# Public Comments Received by NIST on Draft Reports:

Technical Study of the Sofa Super Store Fire - South Carolina, June 18, 2007  
*Volumes I and II*  
DRAFTS FOR PUBLIC COMMENTS

October 2010

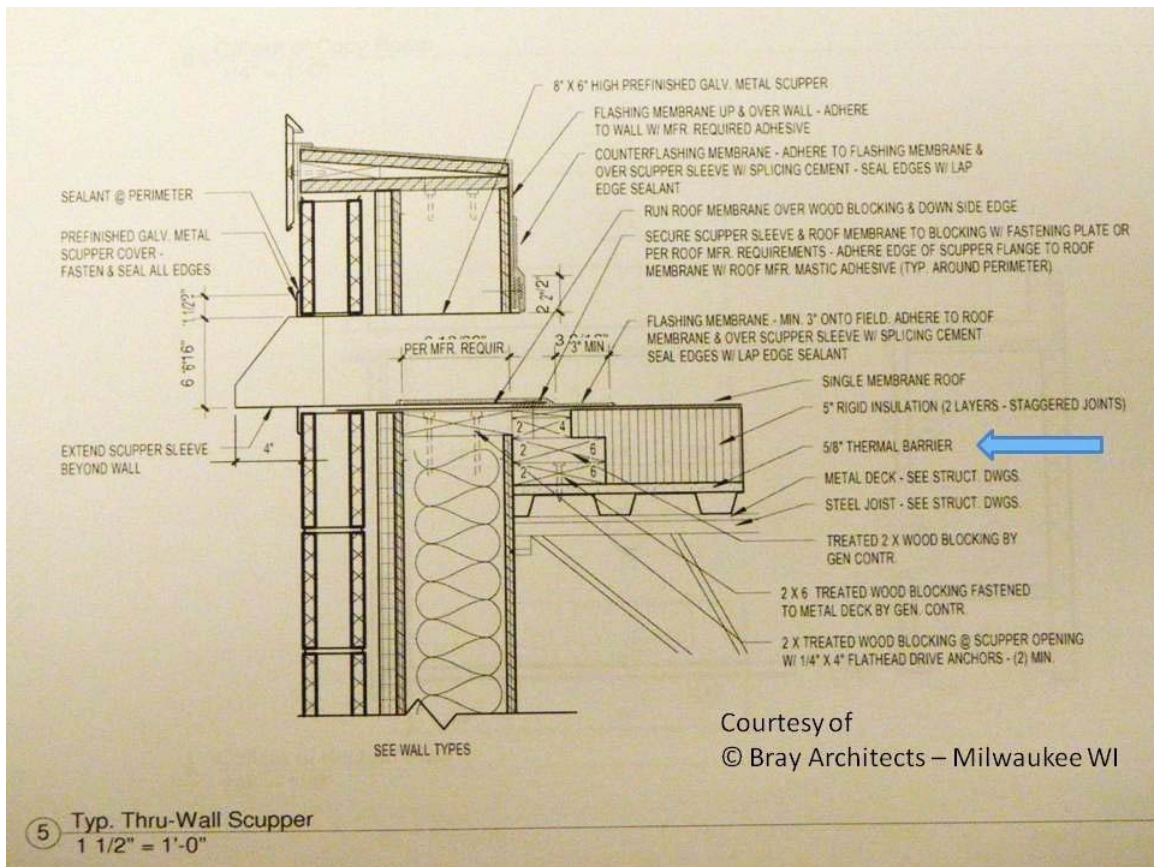
On top of the layers of insulation, a single layer of ethylene propylene diene monomer (EPDM, a type of synthetic rubber) roof membrane (or a similar rubber or plastic product), is laid down; joints are glued or solvent-welded. This membrane is sealed around pipes, vents, ducts, and other roof penetrations; and is ballasted with round gravel. With a fire below, this type of roof behaves like the older-style built-up roof and can develop a fire above the steel roof deck, which then will drip burning and molten plastic and rubber down into occupied space that is not yet affected by the original fire. This behavior could be made worse if the roofer substituted less expensive plain foam insulation board for the flame-retardant-treated foam board that is usually specified.

Roofs of these types are sometimes inaccurately advertised as “fire-rated.” They do not have a “fire rating” from testing under National Fire Protection Association (NFPA) 251, *Standard Method of Tests of Fire Endurance of Building Construction and Materials* (ASTM E119 ) like a wall or a floor-ceiling assembly. Rather, they have been tested under NFPA 256, *Standard Method of Fire Tests of Roof Coverings* (UL 790; ASTM E-108) for exposure to fires originating outside the building. They are rated Class A (severe), B (moderate), or C (light), based on the severity of fire exposure they can withstand. Tests for the rating include ignition from flaming brands, intermittent flame exposure, rain, weathering, and flame spread.

Installing a thermal barrier between the steel deck and the plastic foam insulation on a modern roof is usually about five percent of the cost of the completed roof. However, building owners usually have tight budgets and often give up this fire-resistance feature so that their money can be spent where it will show. After all, the thermal barrier is of no value to the owner or to the business unless there is a fire, and most building owners don’t believe that this can happen to their building.
